# Planning Report

**M/I Homes – 5649 Eden Bridge Drive**

Agenda Number	1
Case Number	15-042SP
Location	5649 Eden Bridge Drive West Side of Eden Bridge Drive, approximately 680 feet north of Rings Road.
Proposal	To all a parking area in association with a model home that will be constructed in the Celtic Crossing subdivision.
Request	Special Permit to Section 153.073(D)(2)(C)(6) to permit a parking lot that will be used in association with a model home.  Requires review and approval by the Board of Zoning Appeals based on the review criteria of Section of Zoning Code Sections 153.231(G)(3) and 153.238.
Applicants	Jean Hajdin, M/I Homes.
Planners:	Tammy Noble, Senior Planner.
Planning Contact:	(614) 410-4649 or tnoble@dublin.oh.us
Planning Recommendation	<b>Approval</b> Based on Planning's analysis, the request meets the review criteria for a special permit and approval is recommended with one condition.  (1) That the existing parking area not be illuminated.

15-042SP  
Special Permit  
M/I Homes  
5649/5571 Eden Bridge Drive

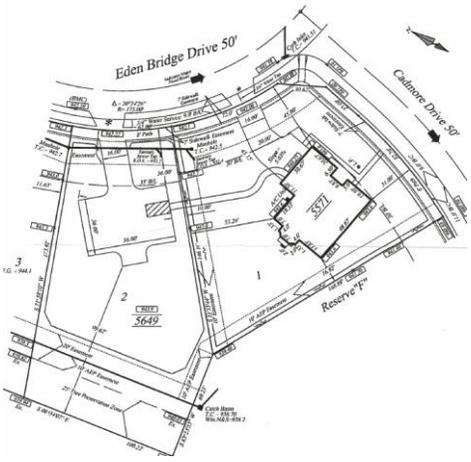
Analysis	Special Permit
(1) <i>Adjacent to Unoccupied lots</i>	<b>Standard Is Met.</b> All of the surrounding lots are unoccupied.
(2) <i>Parking Lot Does Not Extend Beyond the Rear Elevation</i>	<b>Standard Is Met.</b> The parking lot is parallel with the center portion of the model home and therefore, does not extend beyond the rear of the home.

(3) <i>Parking Lot Does Not Extend Forward of Front Elevation</i>	<b>Standard Is Met.</b> The parking lot does not extend forward of the home.
(4) <i>Sidewalk Is Provided from Model Home to Parking Lot</i>	<b>Standard Is Met.</b> The proposal includes a sidewalk that connects the parking area to the model home.

Recommendation	Approval
Approval	Based on Planning’s analysis the requested special permit meets the required standards, therefore approval of the special permit is recommended with one condition.
Condition	1) That the existing parking area not be illuminated.
